1. The specifications and drawings for Invitation No. W912HY-04-B-0014, Pipeline Dredging, Upper Bay and Barge Lanes in Chambers and Harris Counties, Texas (45-Foot Project), Houston-Galveston Navigation Channels, Texas, advertised 10 May 2004, and for which bids are to be opened on 9 June 2004, are hereby modified as follows:

**HOUSTON-GALVESTON NAVIGATION  
CHANNELS, TEXAS, (45-FOOT  
PROJECT), UPPER BAY AND BARGE  
LANES IN CHAMBERS AND HARRIS  
COUNTIES, TEXAS, PIPELINE DREDGING**

(To Accompany Amendment No. 0001 to Invitation No. W912HY-04-B-0014)

SKETCH NO. 1

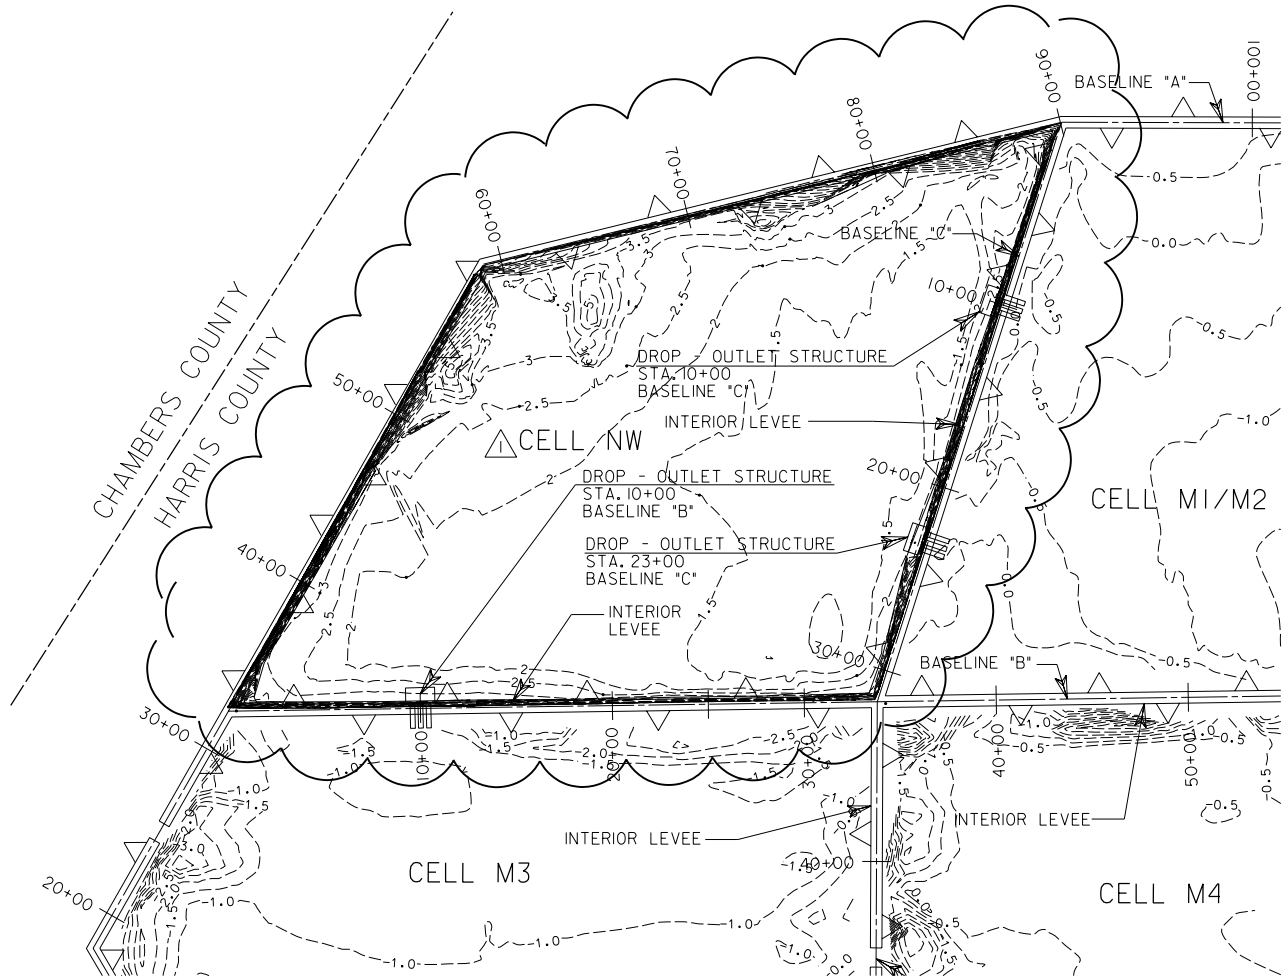
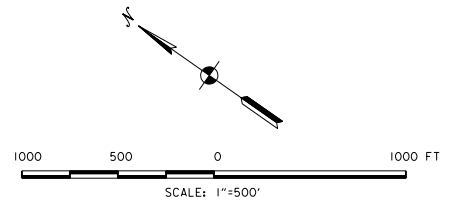
(1) Drawing No. C-10. - The enclosed SKETCH NO. 1 shall be added to and become part of this Drawing. Also, change the "RAISED LEVEE" symbol along the DEMONSTRATION MARSH levee to "EXISTING LEVEE (APPROX. LOCATION)."

△ AM\*0001 NEW BATHYMETRY/TOPOGRAPHY FOR CELL NW

TO BE ADDED TO DRAWING C-10
